**SUBJECT:** North Shore Connector  
NSC Train Systems (System Wide)  
Contract No. NSC-009

- Addendum No. #9 dated October 2, 2008
- Question and Answers 172, 188, 191, 214-219, 222, 224-226, 228-257
- NSC-009 Site Visit – Stage I Tunnel (Gateway Fan Rooms) Attendance Sheet
- Form B (Unit Price Schedule), Sheets B-2 through B-10 Excel file (A9-NSC-009 Form B.xls).

This Addendum modifies Bid Documents for the subject Contract as set forth below. The Bidder shall acknowledge receipt of this Addendum in the appropriate space on the Form of Proposal, Form B.

CONTRACT NO.: NSC-009  
DWG. NO.: TP217  
SHT. 319

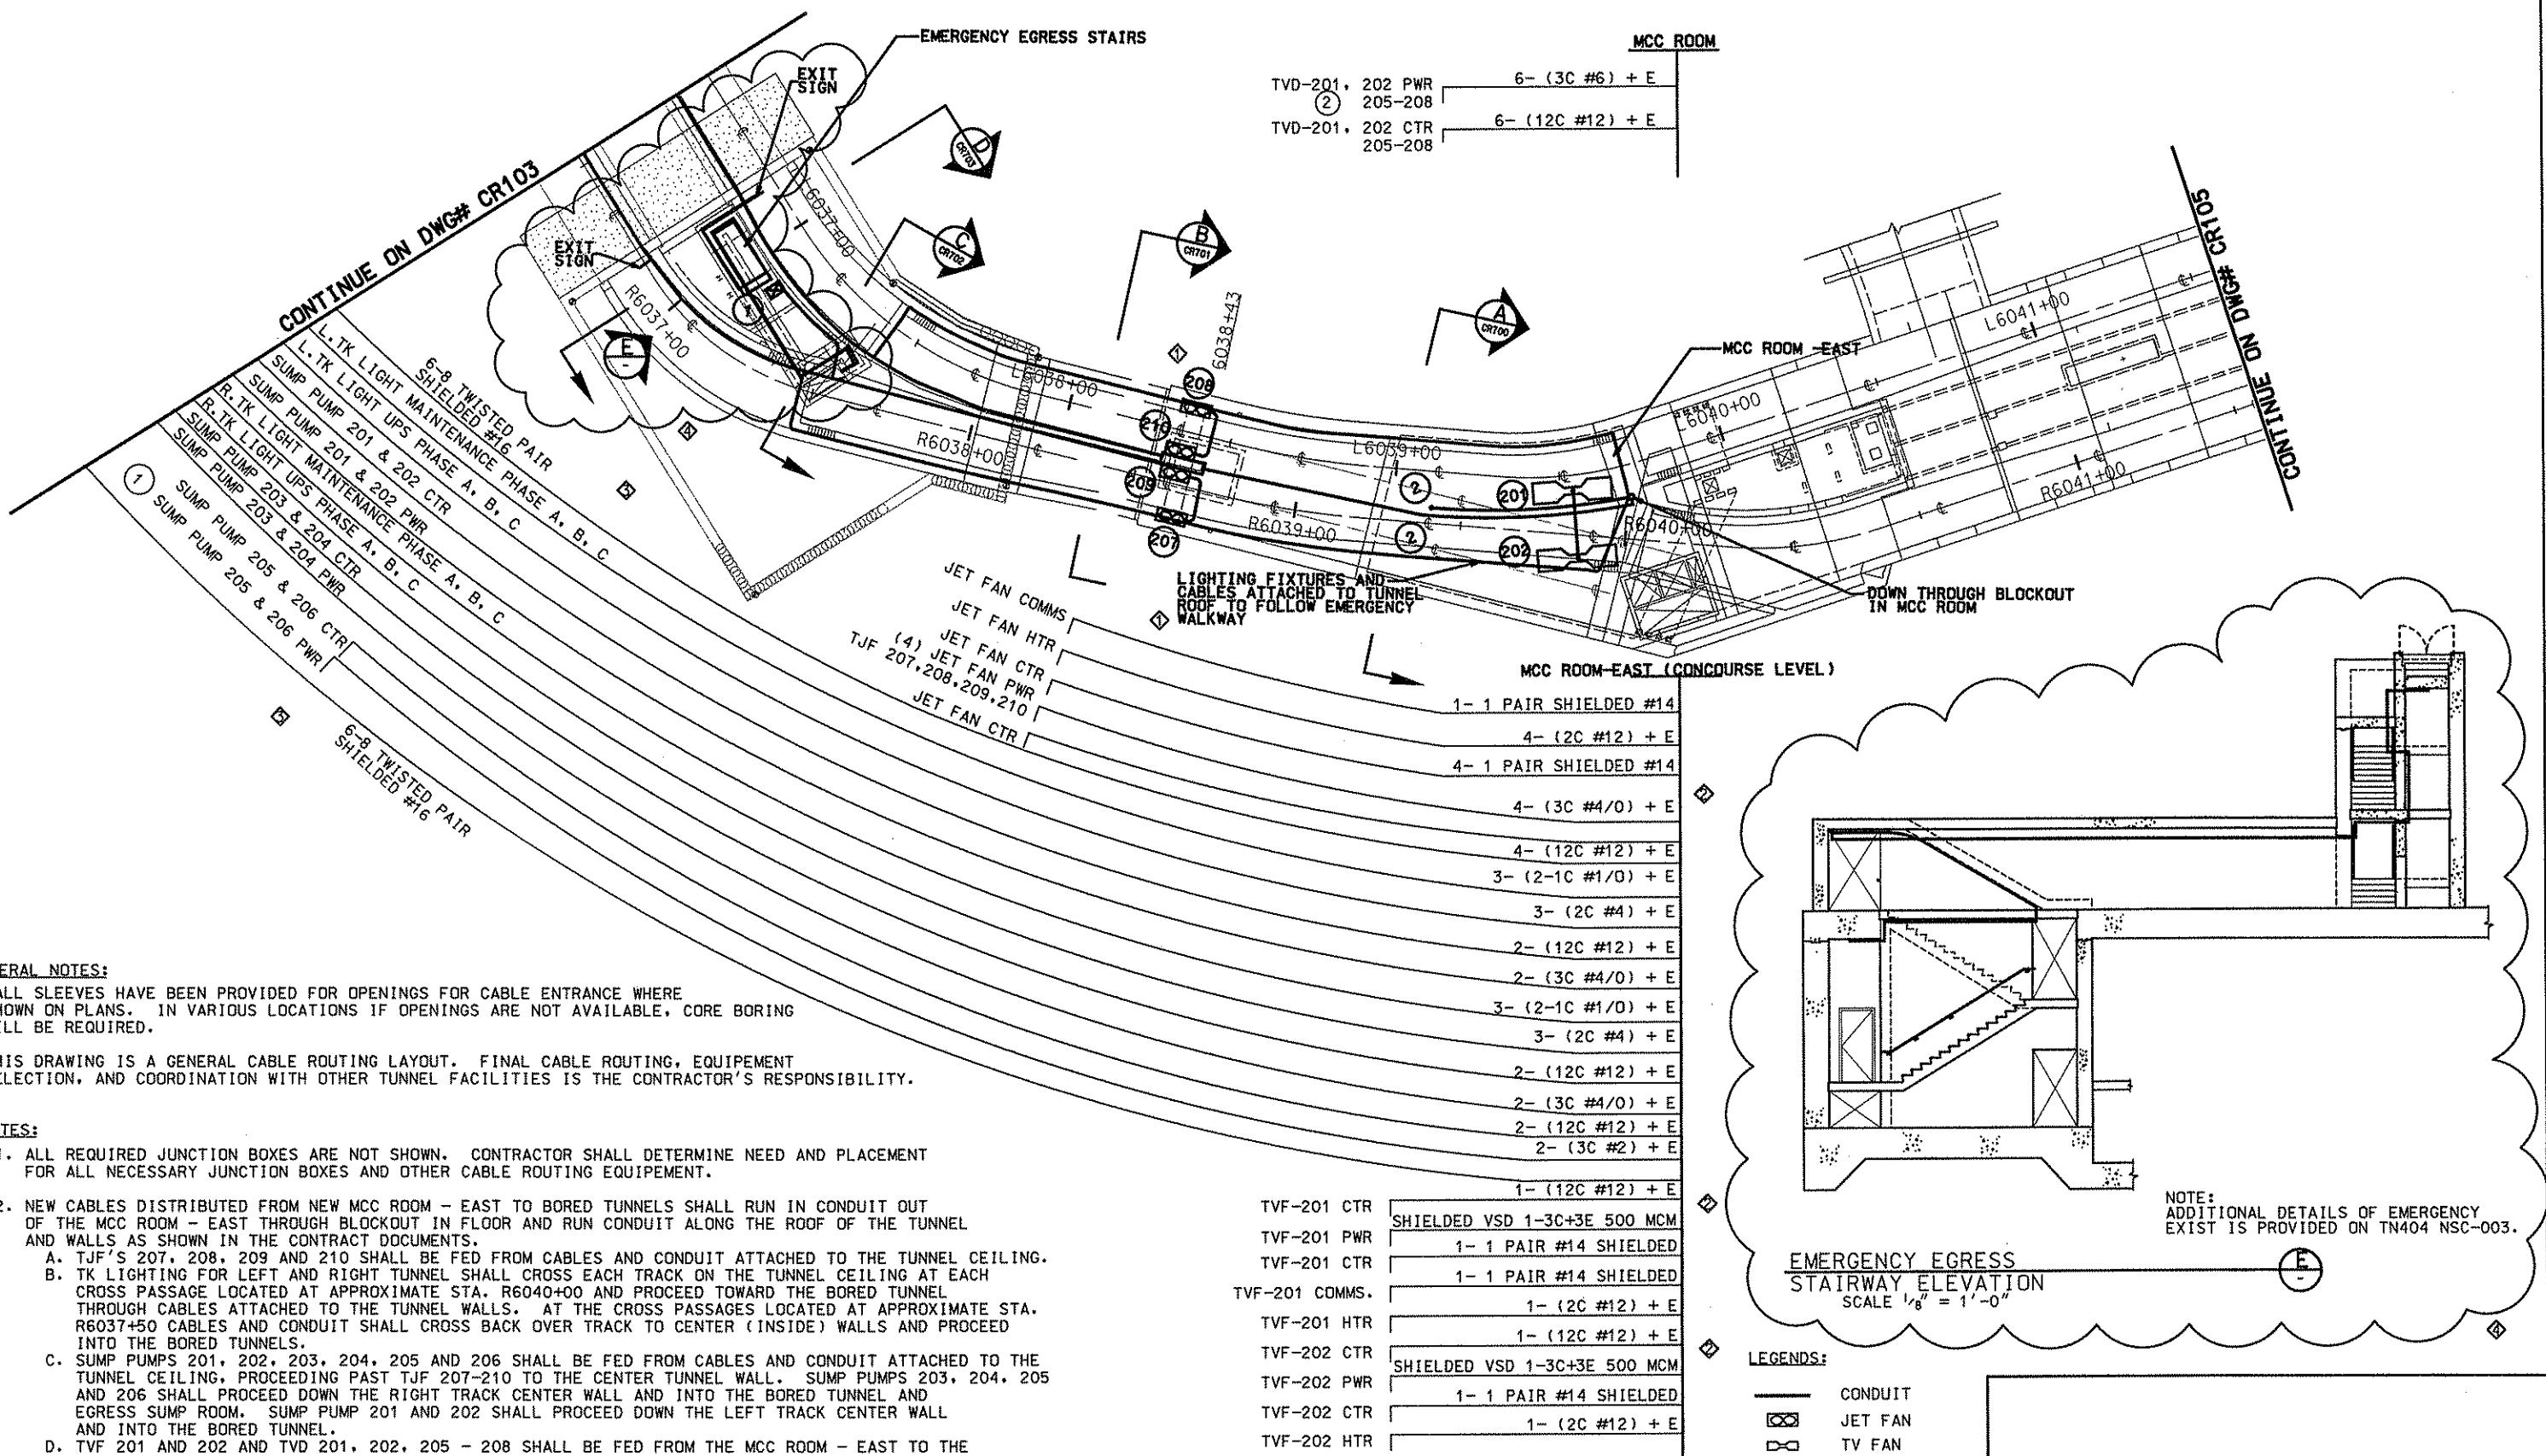
Question 222: There is a discrepancy regarding the positive feeder locations at Allegheny location. Drawing sheet no. 176 shows the tie-in locations to the OCS at 6084+50 and 6084+90. However, drawing sheet no. 319 shows the tie-in locations to the OCS at 6088+85 and 6088+86. Which is correct? Please advise.

Response 222: Drawing Number OC110, Sheet no. 176 is correct. See Addendum 9.

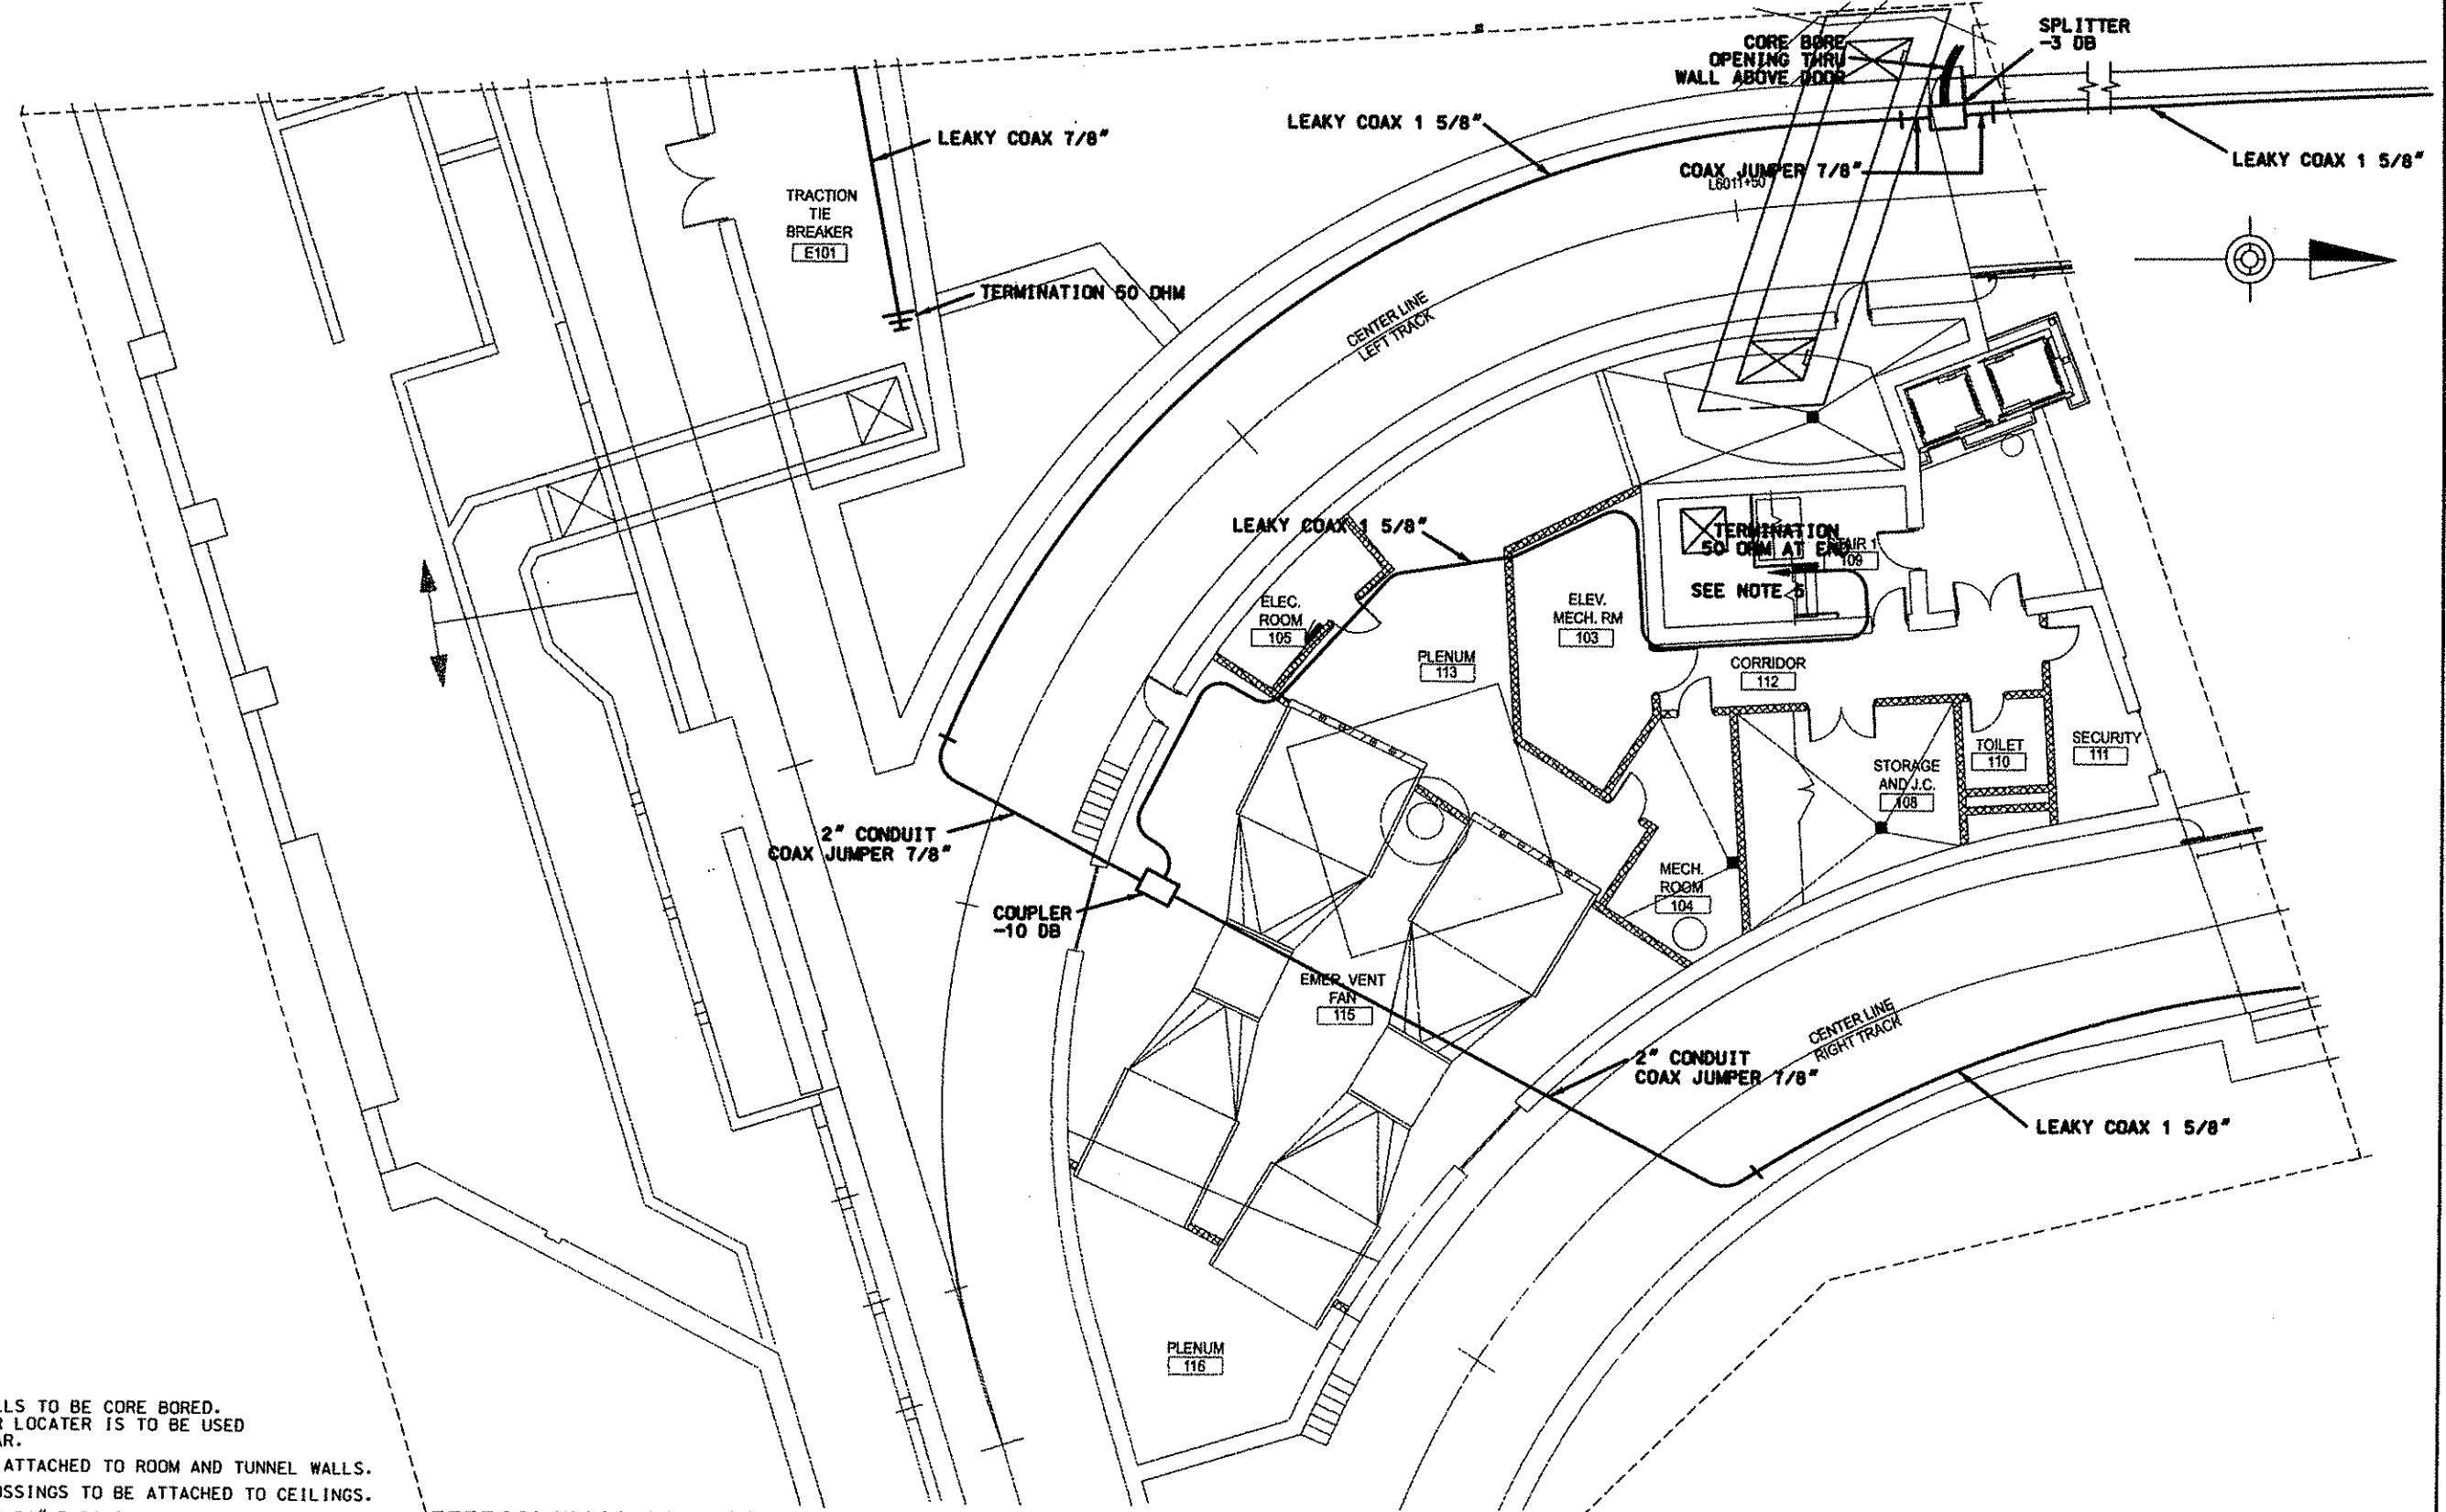
Question 224: Please provide a scaled drawing of contract drawing sheet nos. 587, 591, 592, 595, and 596 so that cable and conduit footages can be estimated.

Response 224: See Addendum 9.
